# CITY OF ALBUQUERQUE

RE: **Jefferson Hotel**  
**Restaurant Ln NE**  
**Grading Plan Stamp Date: 8/15/18**  
**Drainage Report Stamp Date: 8/15/18**  
**Drainage File: F17D044C**

RE: **Jefferson Hotel**  
**Restaurant Ln NE**  
**Grading Plan Stamp Date: 7/30/18**  
**Drainage Report Stamp Date: 7/30/18**  
**Drainage File: F17D044C**

DRAINAGE REPORT

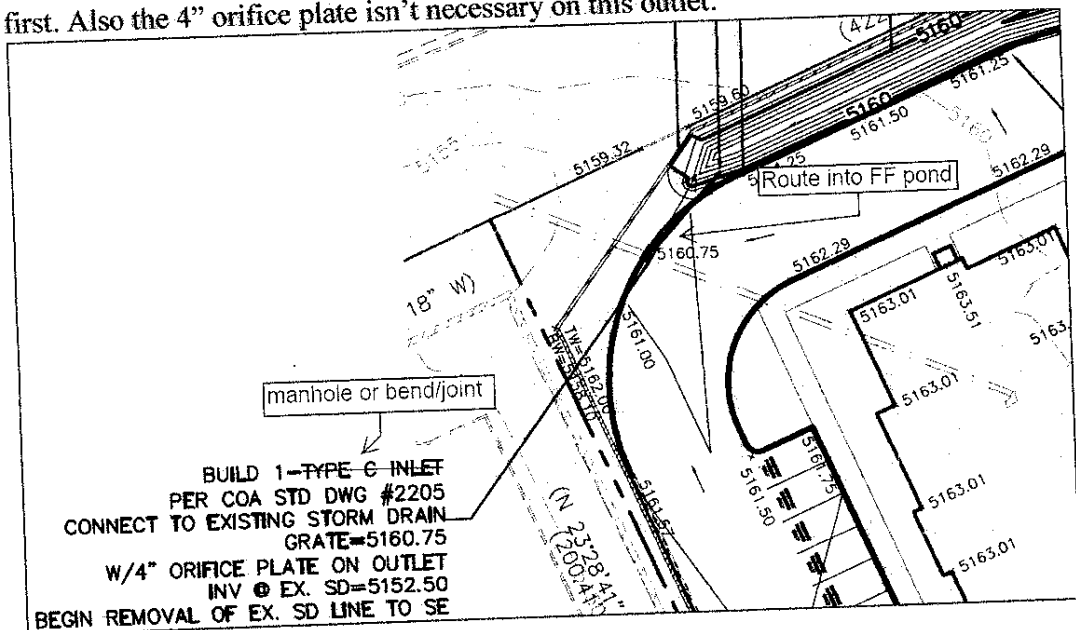
1. The Type C inlet at the NW corner should be removed as it allows surface flows to bypass the first flush pond. Stormwater draining to this low spot will need to be routed to the pond first. Also the 4" orifice plate isn't necessary on this outlet:

CORRECTED
